Re: 708 E. 12th Street – Downtown Density Bonus Program (“DDBP”) Application and Summary of Compliance with the City of Austin’s Urban Design Guidelines for a hotel tower project located at 708 E. 12th Street and 1200 N IH-35 Service Road related to site development permit application case SP-2022-0543C.

Date: June 12, 2023  
To: City of Austin Design Commission  
From: Planning & Urban Design Working Group  
Subject: Density Bonus Working Group review of 708 E 12<sup>th</sup> Street substantial compliance with the Urban Design Guidelines  
Meeting date: June 7, 2023; 12:00 pm; Virtual Microsoft Teams Meeting  
Applicant: Leah M. Bojo

## **WORKING GROUP REVIEW OF PROJECT FOR COMPLIANCE WITH THE URBAN DESIGN GUIDELINES**

**BUILDING ELEVATIONS - EAST & SOUTH**

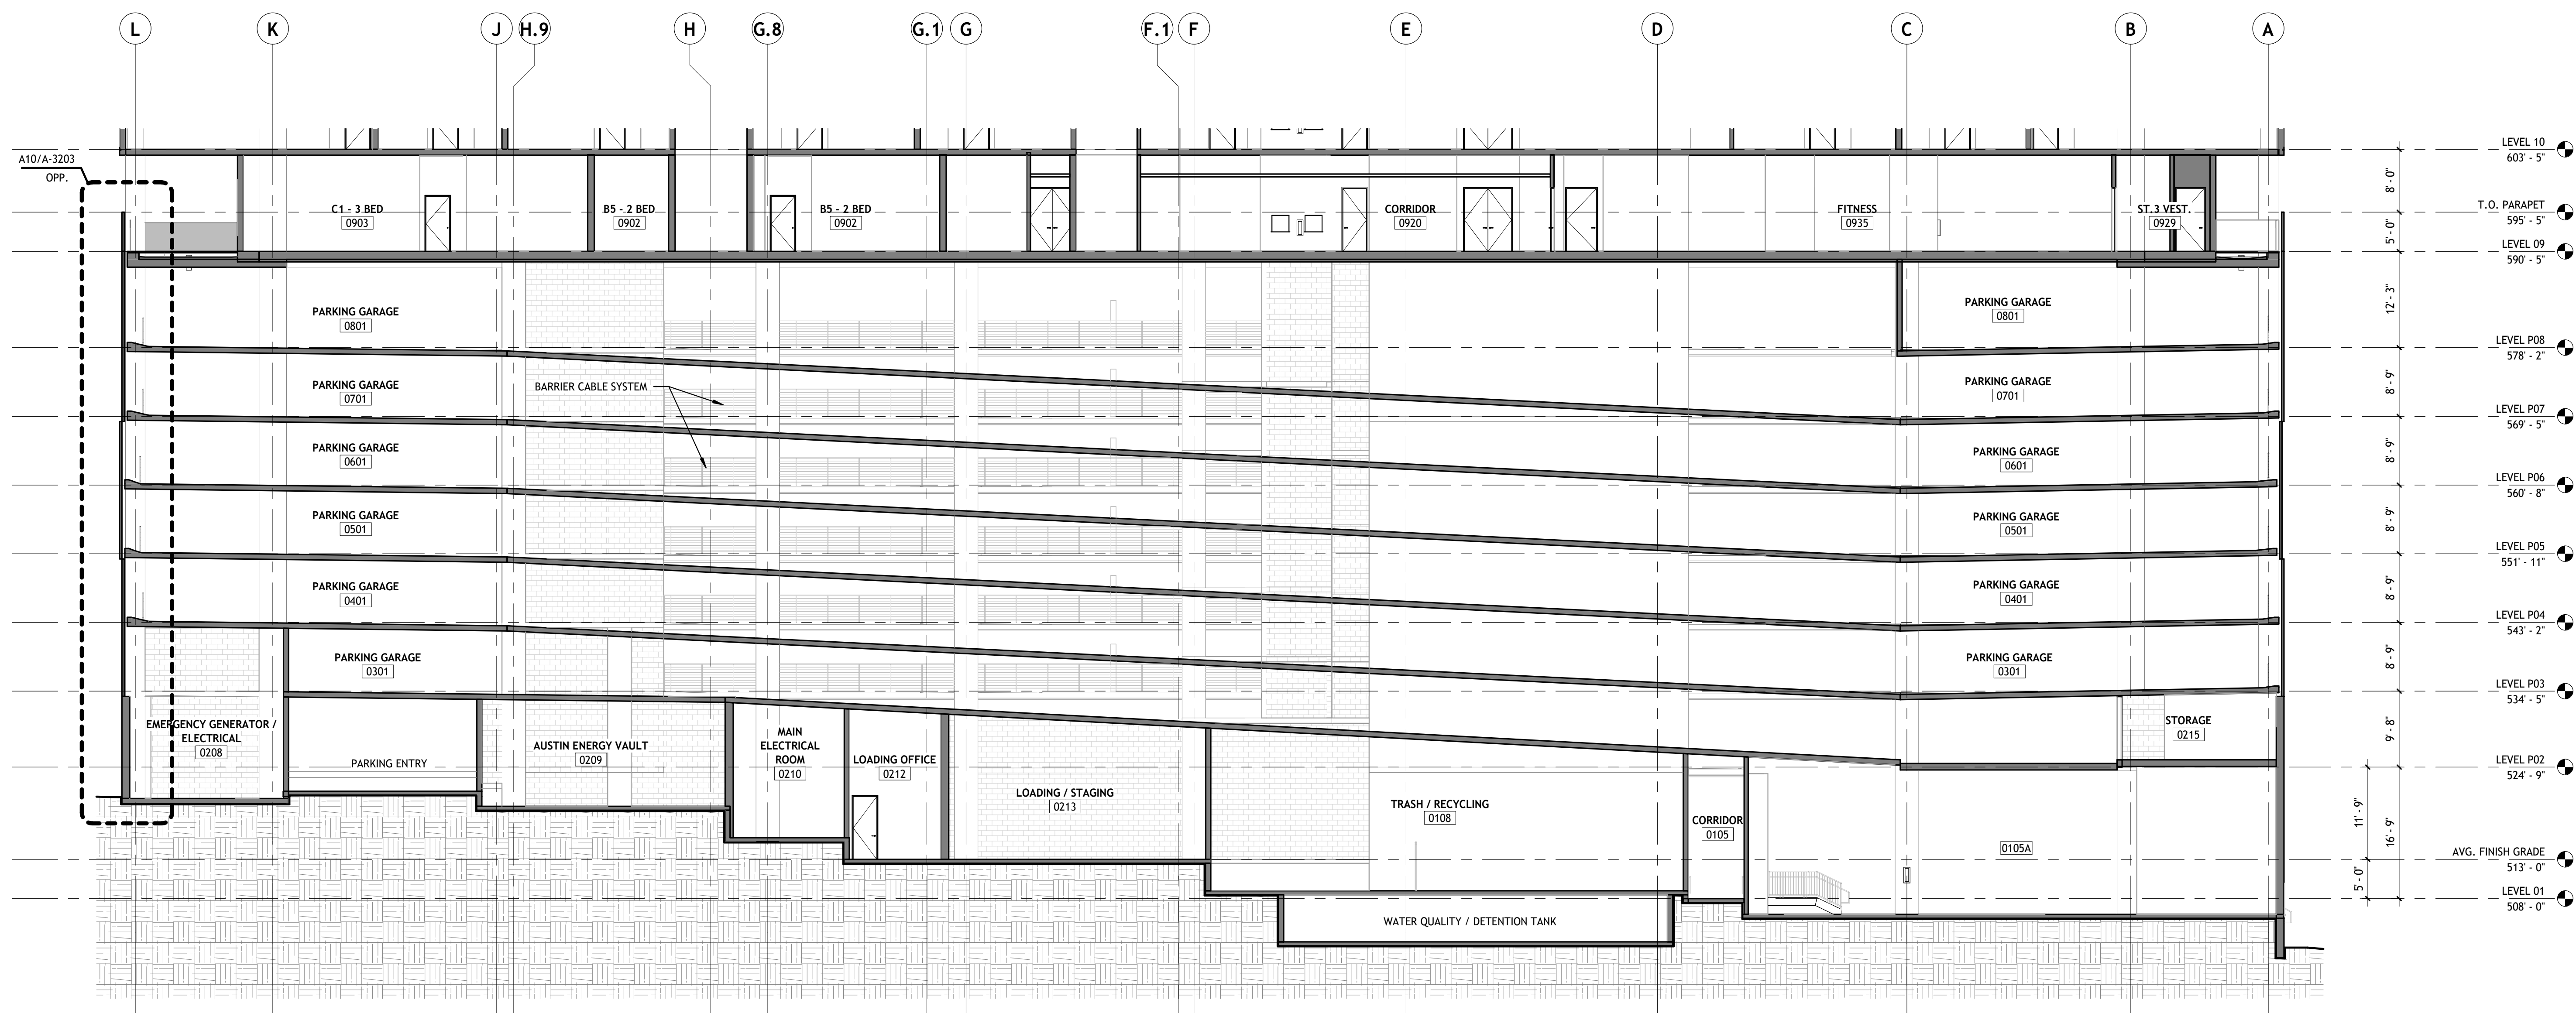
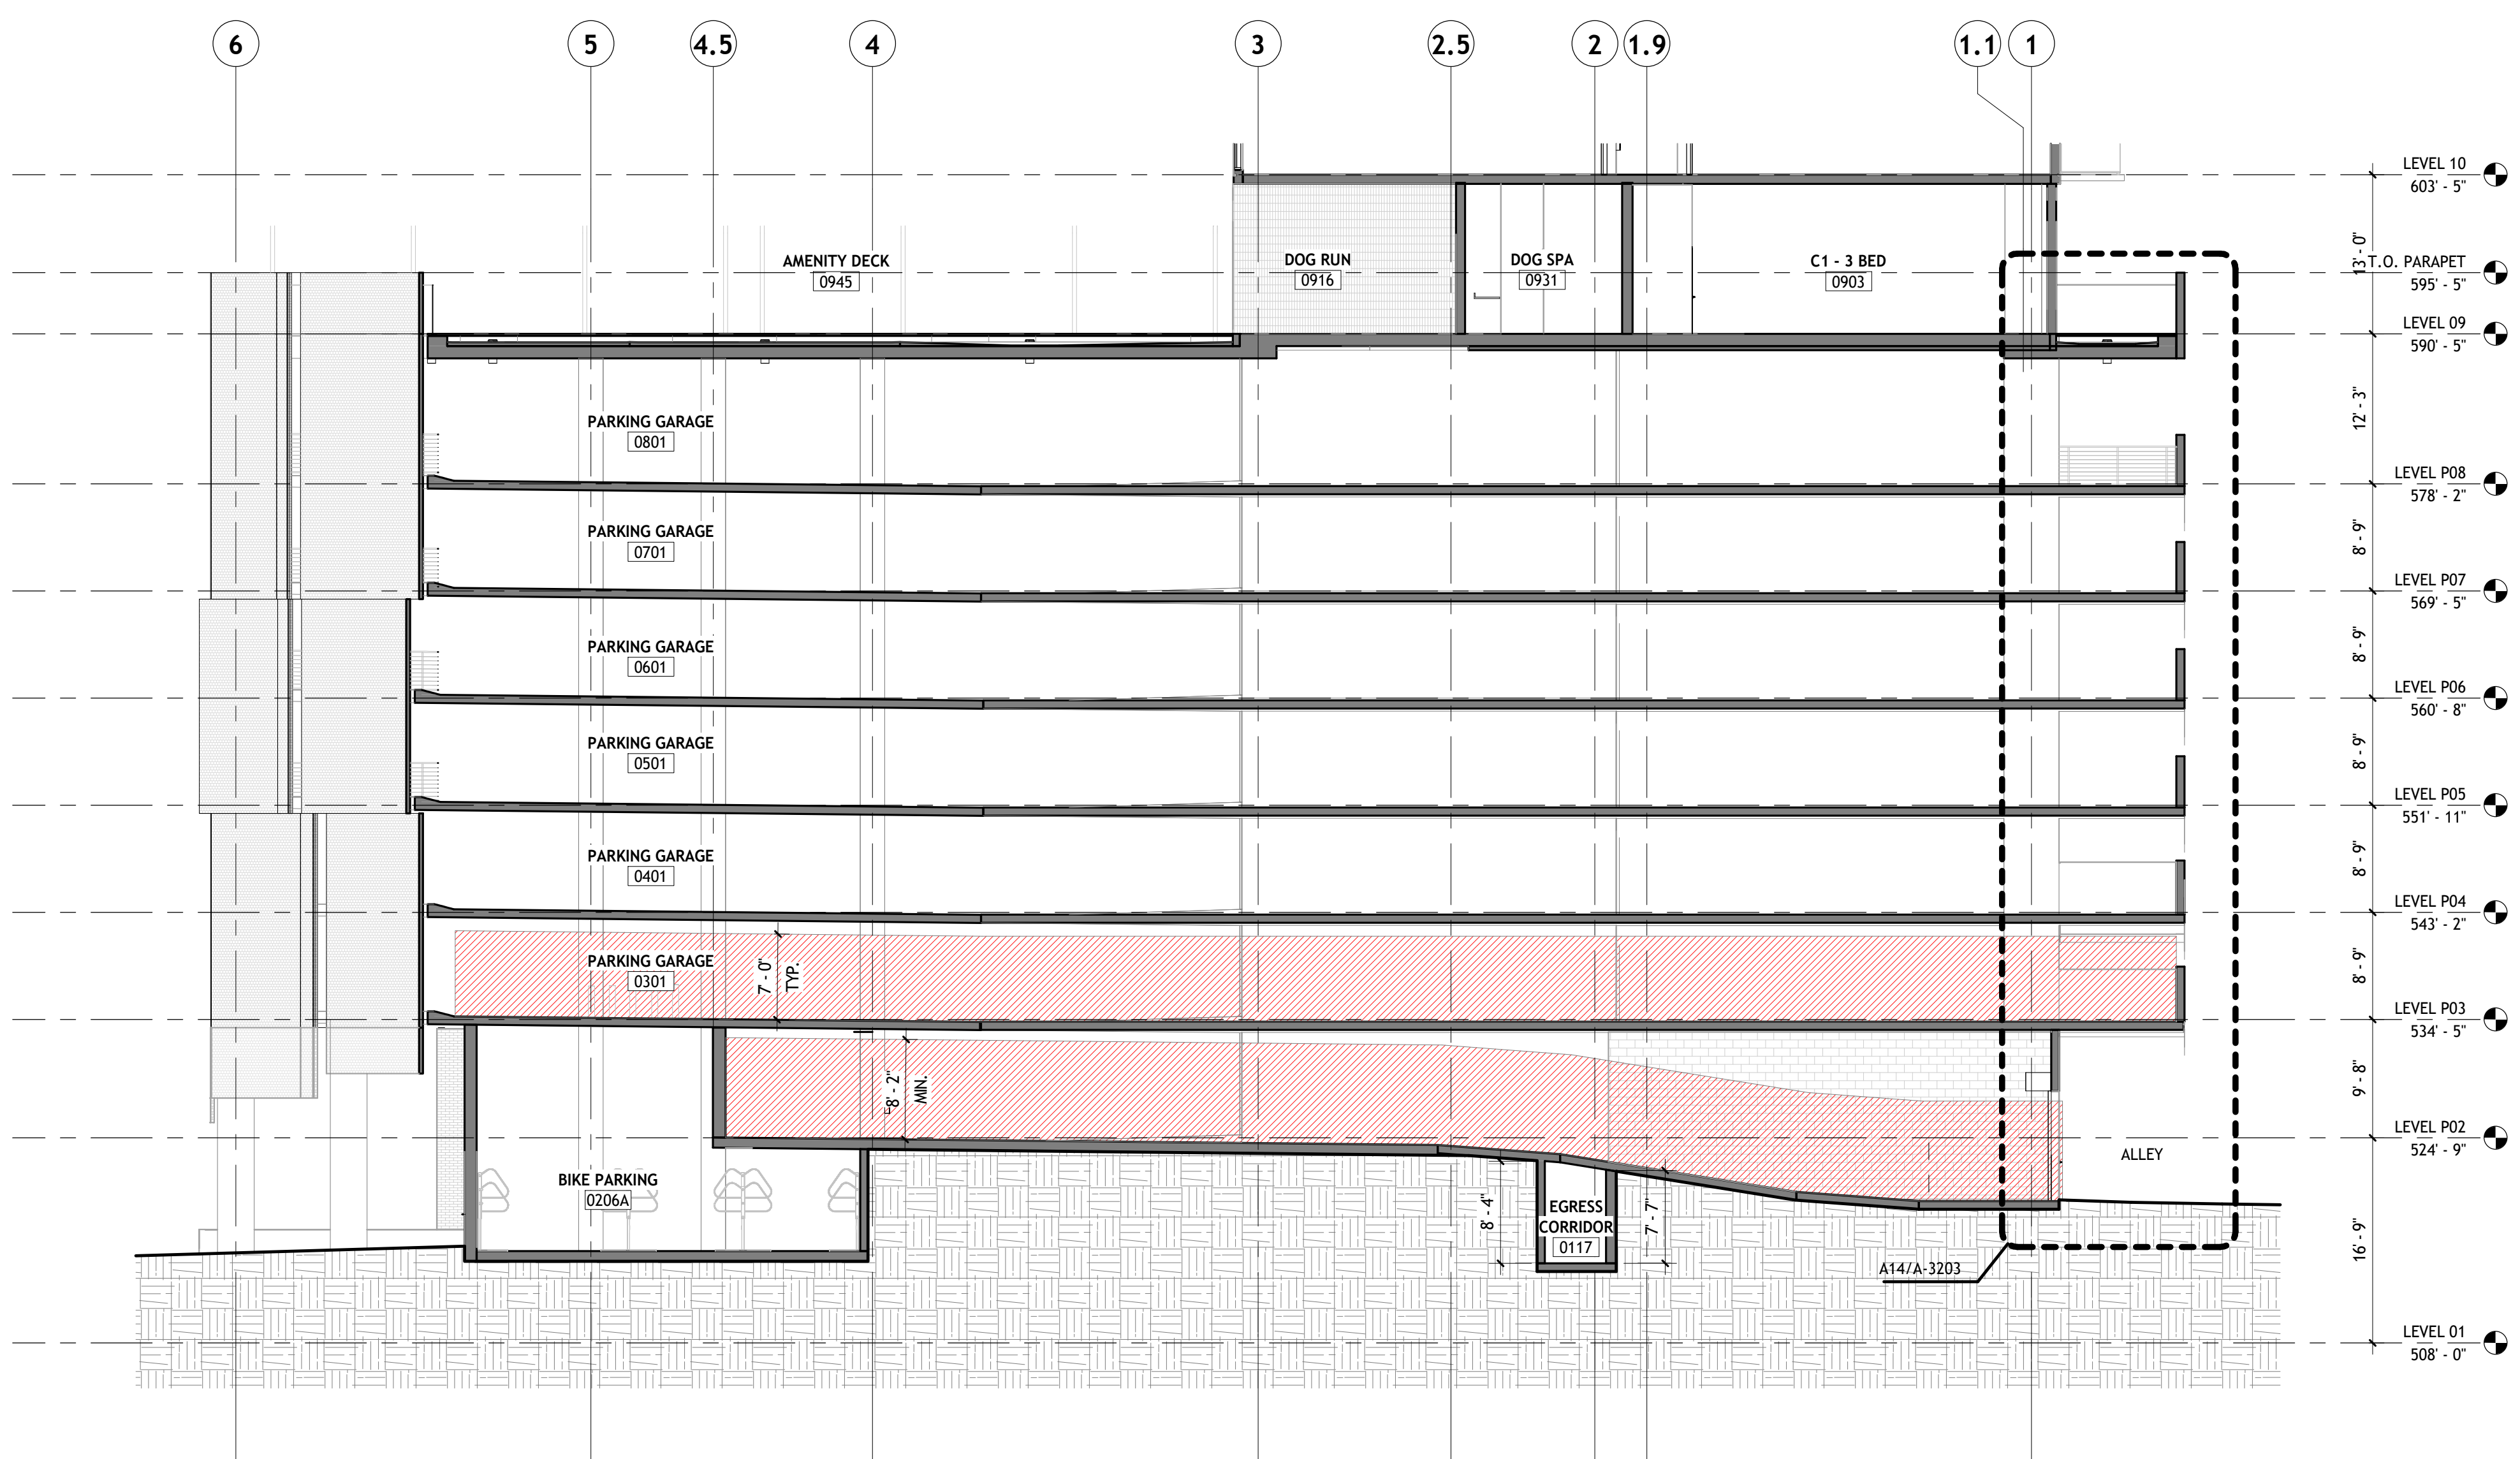
- PS13 - East and North sides of building need further refinement as it relates to views from S I-35 and Frontage rd. S I-35 Frontage does have a sidewalk and East façade should provide more friendly façade to potential pedestrians.

- B7 - Project more human scale facades on North and East sides of buildings. Even though they face the substation and S I-35 they will be viewed by many humans each day
